**DESIGN MEMORANDUM**  
**13**  
**COOPER RIVER REDIVERSION PROJECT**  
**LAKE MOULTRIE AND SANTEE RIVER**  
**SOUTH CAROLINA**

**COOLING WATER**  
**FACILITIES**

SADEN-GP (15 Oct 80) 1st Ind  
SUBJECT: Cooper River Rediversion Project, Lake Moultrie and Santee  
River, South Carolina, Design Memorandum 13 - Cooling Water  
Facilities

Figure 1

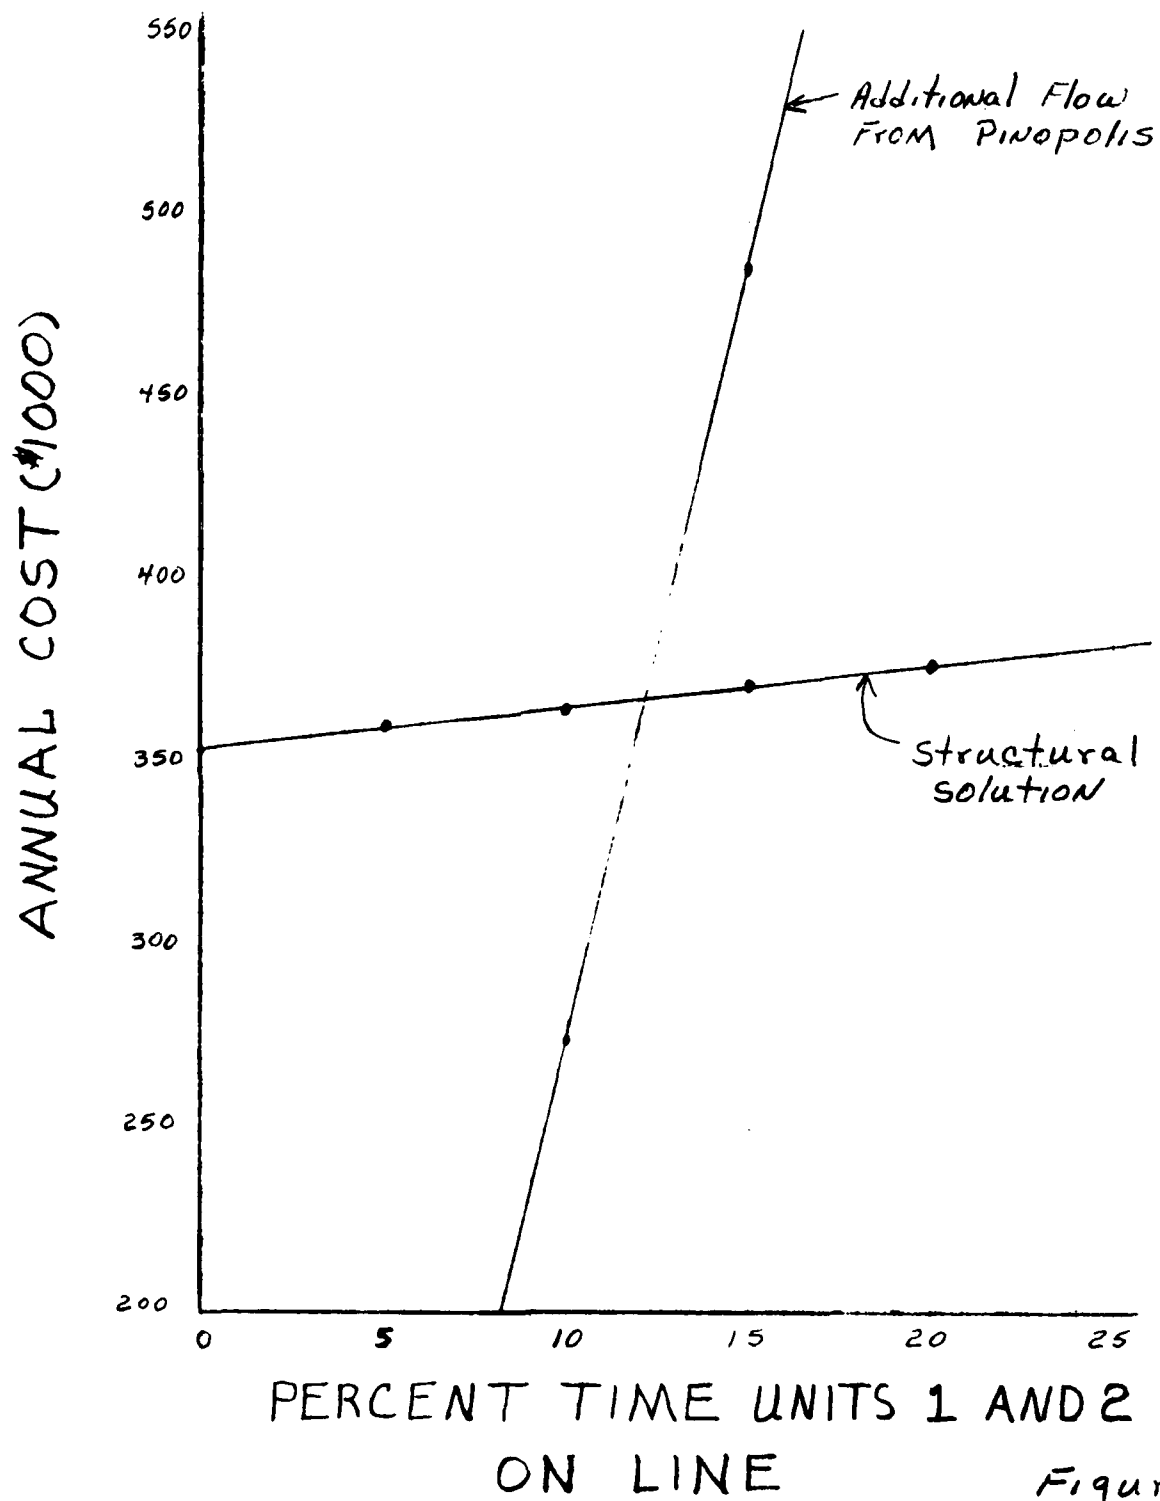
e. Page 6, paragraph 22. It should be explained why Table 1 and Table  
2 differ and why Table 1 values are selected for the analysis of alternatives  
shown in Figure 1.

COOPER RIVER  
SHOWING  
PREDICTIONS  
COMPLETED

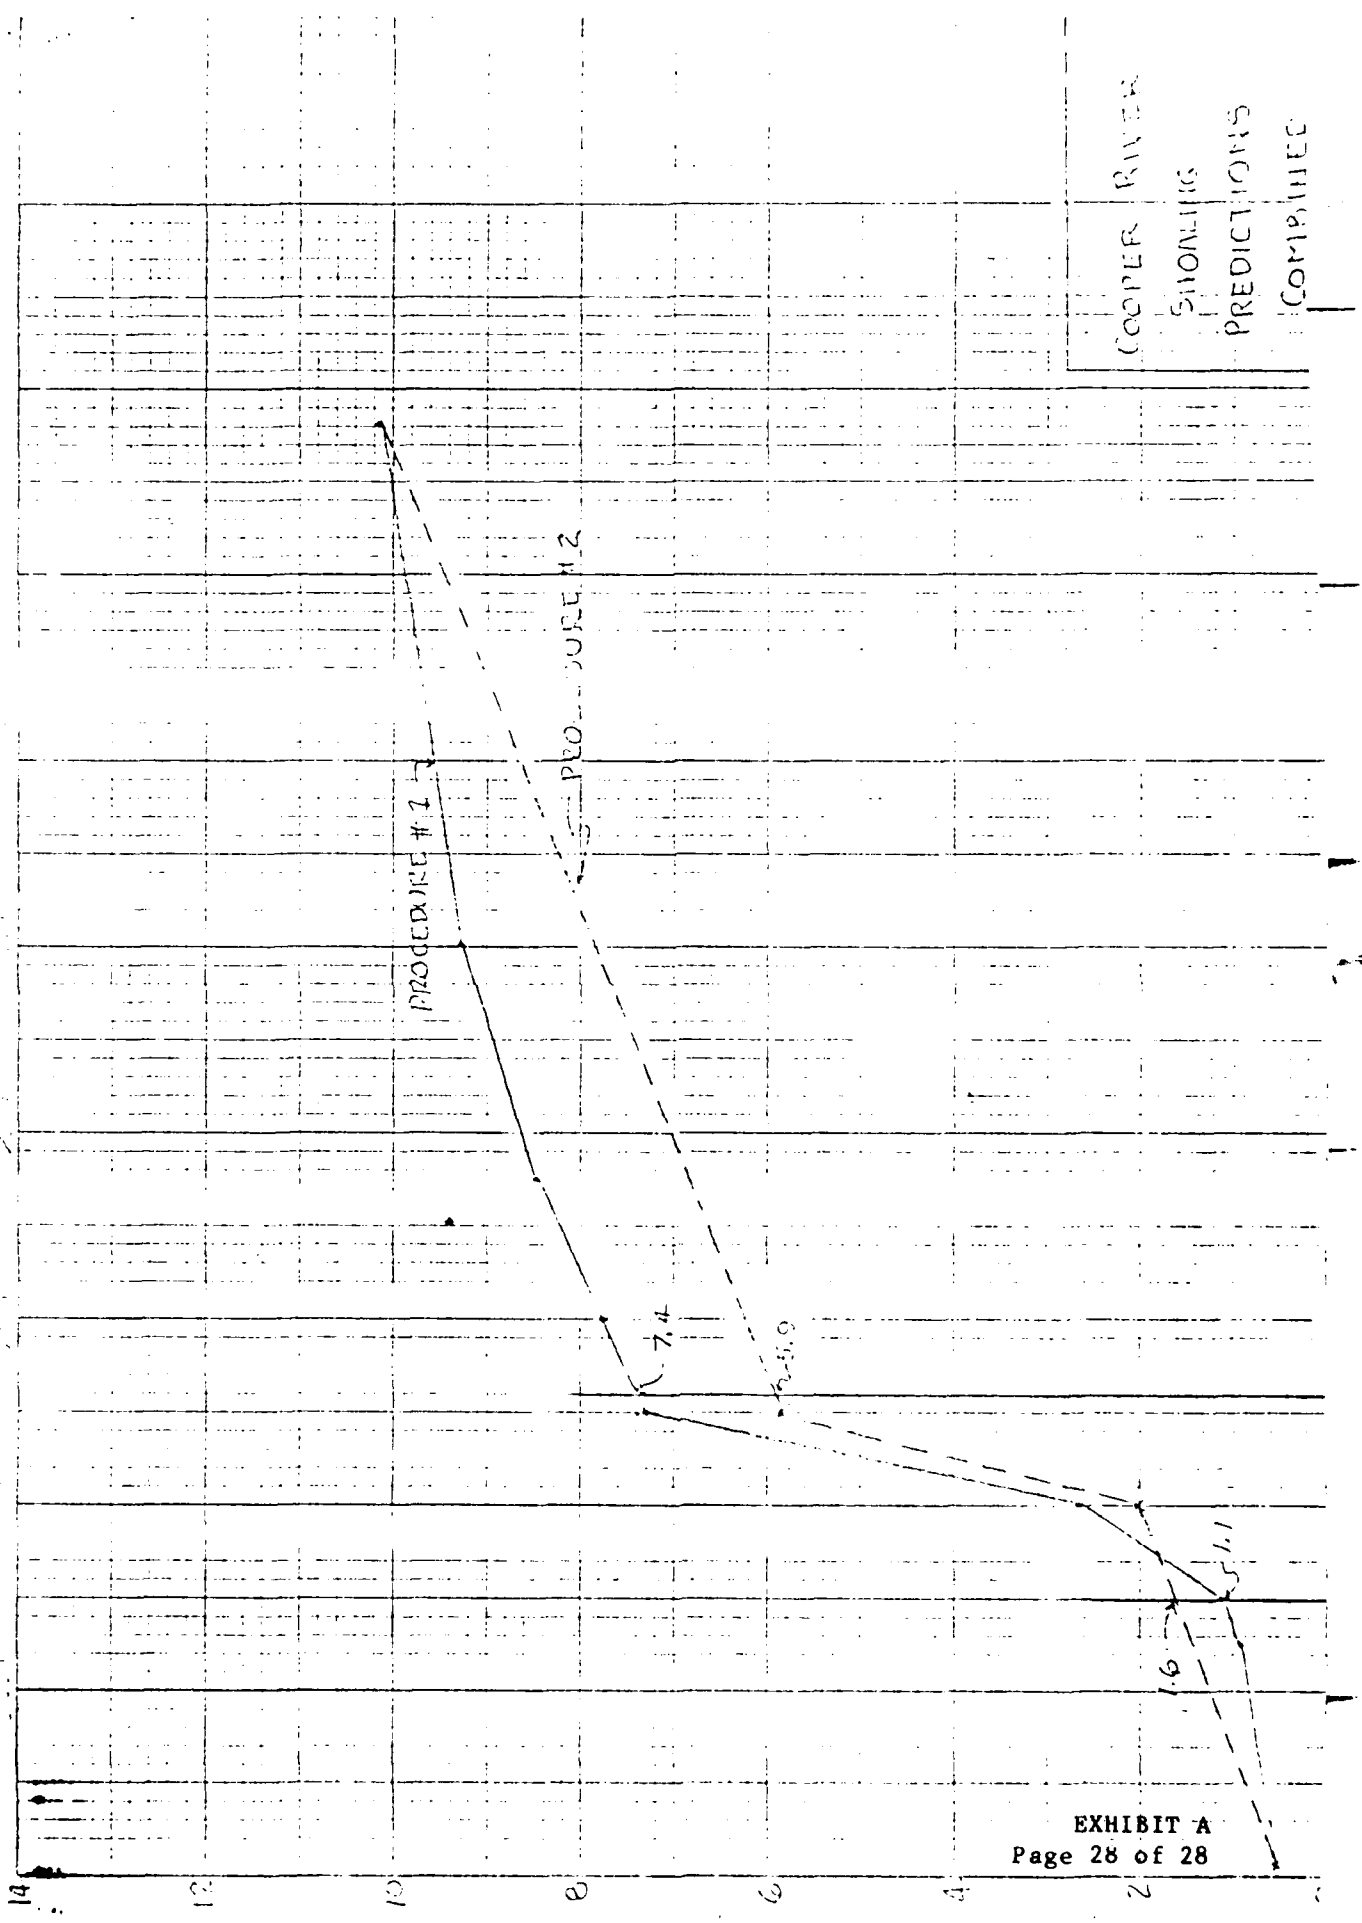
c. Page 5, paragraph 20. Figure 19 is not identifiable in Exhibit A  
due to poor reproduction. We assume Figure 19 is on pages 26-28 of Exhibit  
A. However, the absicxa and ordinate of these graphs are not legible.  
Clarify.
